Access Compliance Report

Public Rights-of-Way

(Curb Ramps)

Intersection ID: 16872	Main Street: TRYON_ST	Cross Street: PRESSLEY_RD	Location: NE
ADA ID: 97073EFD7A05	Ramp Type: Perp	Initial Pass/Fail: Fail	Overall Compliance: No
			Severity Score: 33.75

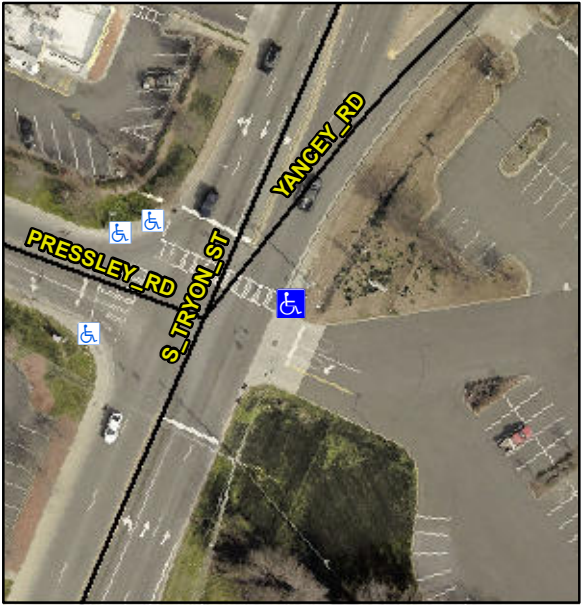
Codes/Mitigation Info/Possible Solution			Field Measurements/Component Compliance		
	Possible Solutions:		Compliance	Description	Data
	Remove & Replace Entire Ramp.		No	Ramp Length (in)	93.0
			No	Ramp Width (in)	45.0
			N/A	Flare Type LT	N/A
			N/A	Flare Slope LT (%)	N/A
			N/A	Flare Traversable LT?	N/A
			N/A	Landing Length (in)	N/A
			N/A	Landing Width (in)	N/A
			N/A	Landing Slope (%)	N/A
			N/A	Landing X Slope (%)	N/A
<p>Surveyor Notes:</p> <p>N/A</p> <p>PROW/ADA:</p> <p>Not Found, R304.5.1, R304.2.2, R304.5.3</p>			N/A	Flare Type RT	N/A
			N/A	Flare Slope RT (%)	N/A
			N/A	Flare Traversable RT?	N/A
			N/A	DWS Provided?	N/A
			N/A	DWS Contrast?	N/A
			N/A	DWS Length (in)	N/A
			N/A	DWS Full Width?	N/A
			N/A	DWS Offset (in)	N/A
			N/A	Shared Landing?	N/A
			N/A	Gutter Ponding?	N/A
			N/A	Gutter Lip Ht (in)	N/A
			N/A	Painted X Walk1?	Yes
				X Walk 1 Direction	To NW
			N/A	X Walk 1 Width (in)	105.0
				X Walk 1 Slope (%)	0.5

X Walk 1 X Slope (%)	4.4
			N/A	Ramp inside XWalk1?	Yes
			N/A	Road Slope (%)	N/A
			N/A	Road X Slope (%)	N/A
			N/A	Any Obstructions?	N/A
				Obstruction Type	
			N/A		
			N/A		
			N/A		
			N/A		
			N/A		
			N/A		
			N/A		
			N/A		
			N/A		
Total Cost:		\$ 1850.00			
			N/A		
			Yes	Surface Condition? (G/P)	Good
